NORTH 18

Design Review Submission: October 5th, 2017 – Resubmitted: September 27th, 2017

APPENDIX D: DESIGN DRAWINGS + DETAILS

Additional Processes And Studies Requested By Staff.

ADDITIONAL NORTH ELEVATION STUDIES REQUESTED BY STAFF

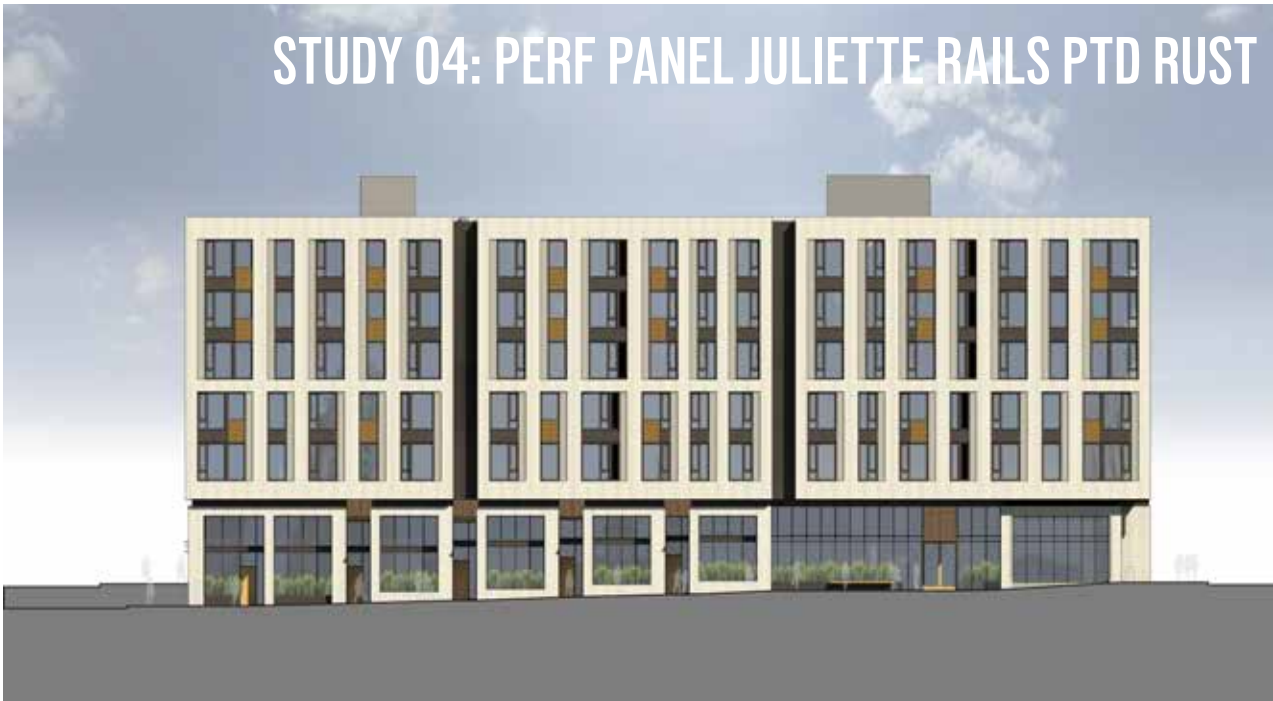
STAFF COMMENT: REGULARIZED WINDOW PATTERN NOT SUCCESSFUL AS IT EMPHASIZES THE VERTICALITY, STUDY USING PREVIOUS OFFSET PATTERNING

ADDITIONAL STUDIES REQUESTED BY STAFF

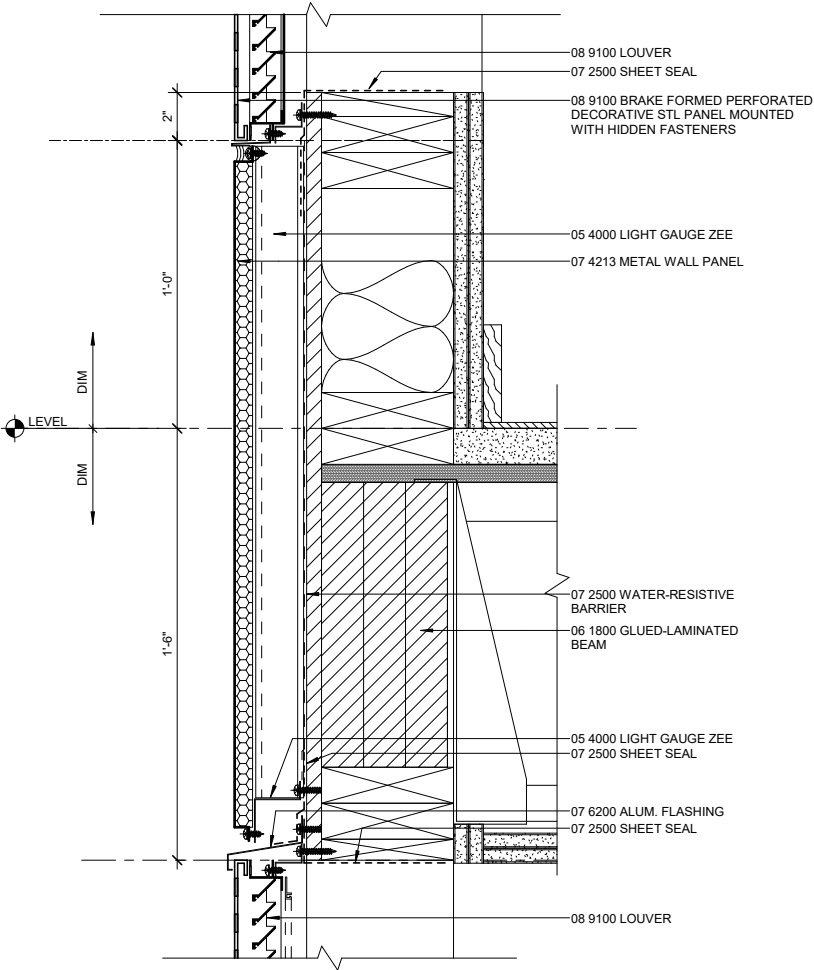
STAFF COMMENT: STUDY MORE BALCONIES BUT RESPOND TO OFFSET PATTERNING

SECTION THROUGH SILL AND PERFORATED PANEL @ MASSING GAP.
1-1/2" : 1'-0"

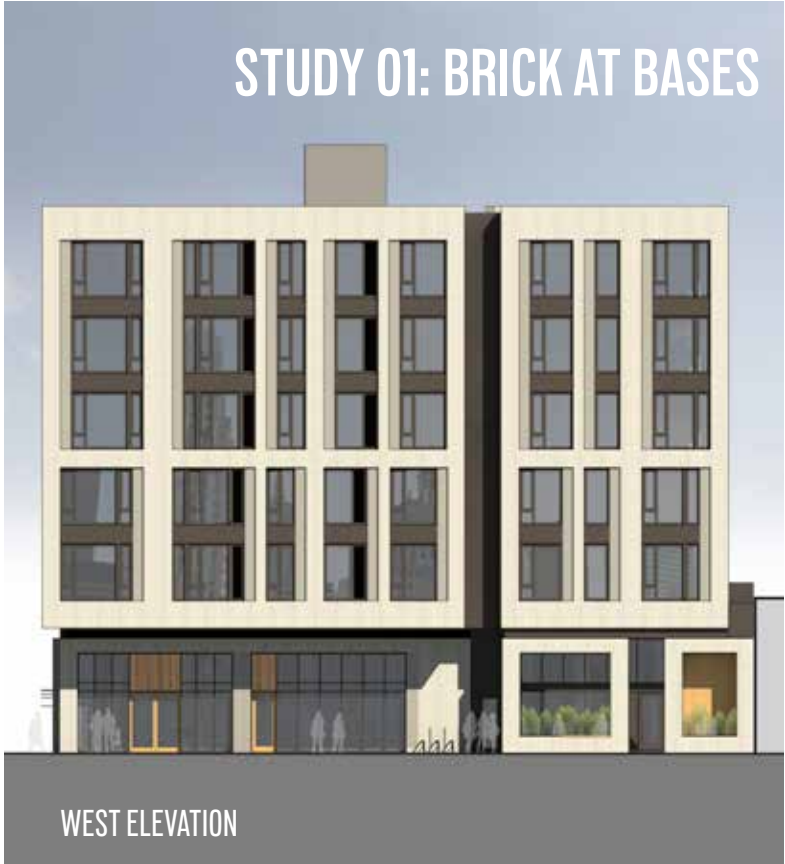
STAFF COMMENT: FULL HT. PERFORATED PANELING NOT SUPPORTABLE

ADDITIONAL STUDIES REQUESTED BY STAFF

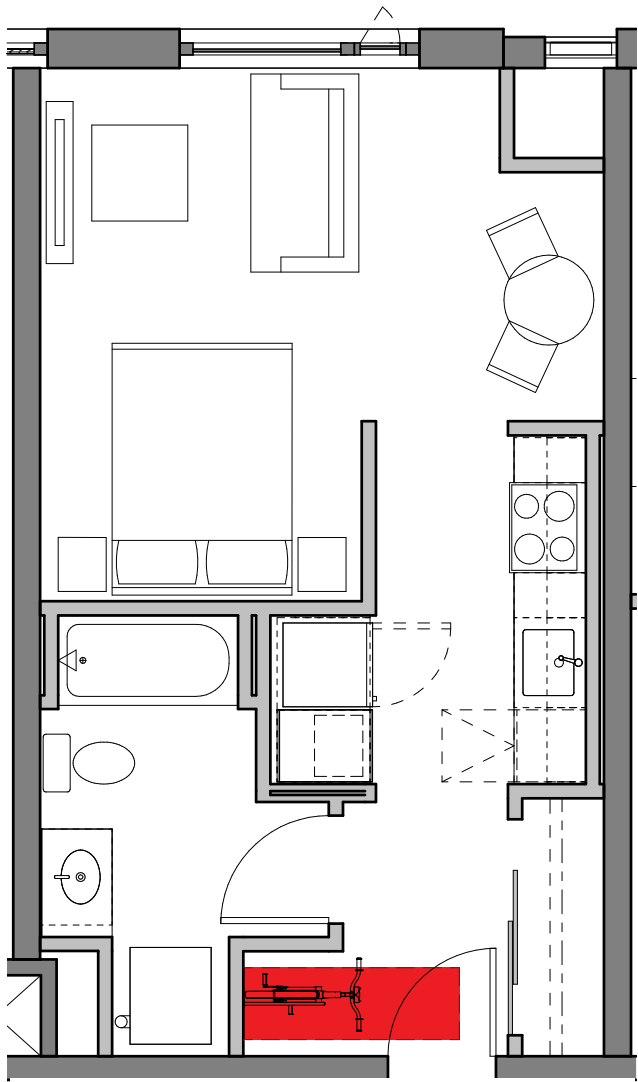
STAFF COMMENT: STUDY THE BRICK SILL VERSUS LACK OF BRICK SILL ON ALL GROUND FLOOR MASSES
